Product Change Notification / NTDO-26ULQD667

CCB 5158 Initial Notice: Qualification of C194 as an additional lead frame material for MTD6508-ADJE/JQ, MTD6508T-ADJE/JQ and MTD6508T-ADJE/JQREL catalog part numbers (CPN) available in 16L UQFN (4x4x0.5mm) package.

CCB 5158

Pre and Post Change Summary

Pre Change

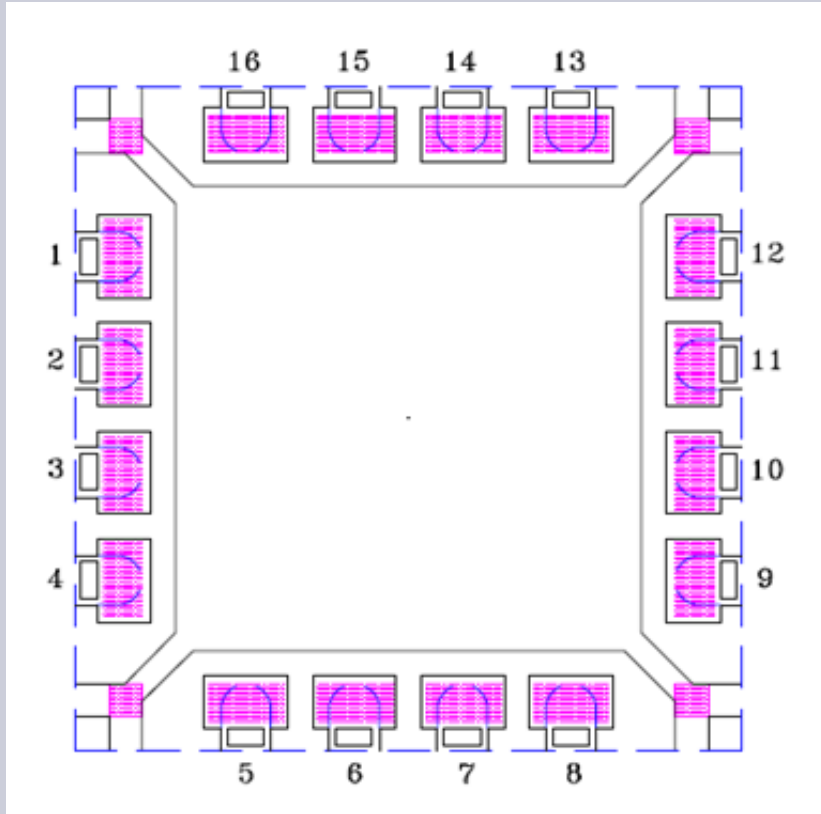
Lead frame Material

EFTEC64T

Post Change

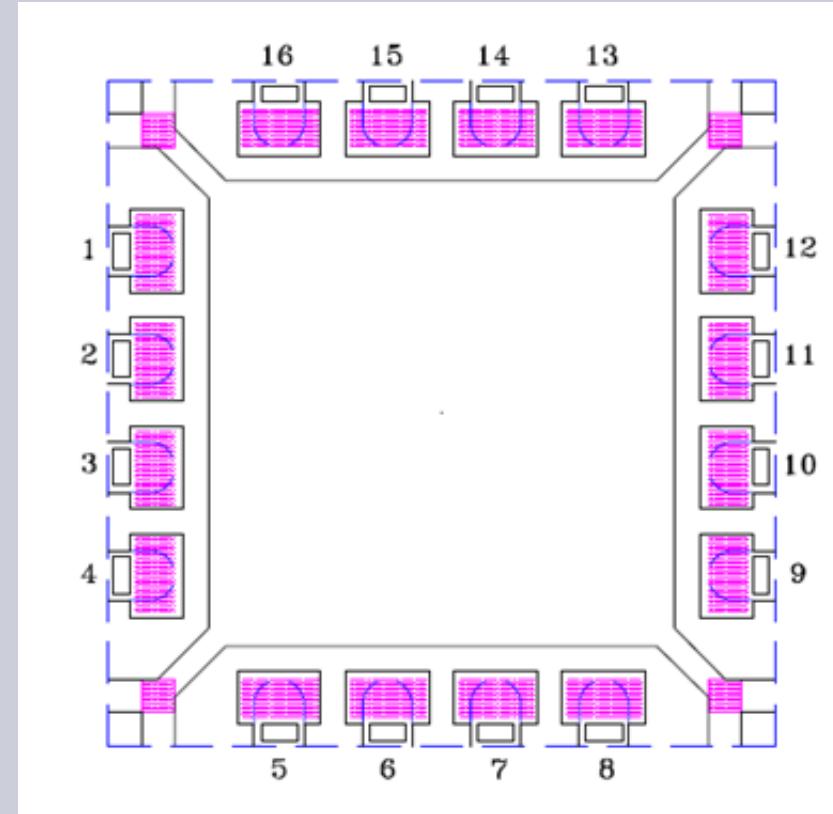
Lead frame Material

C194
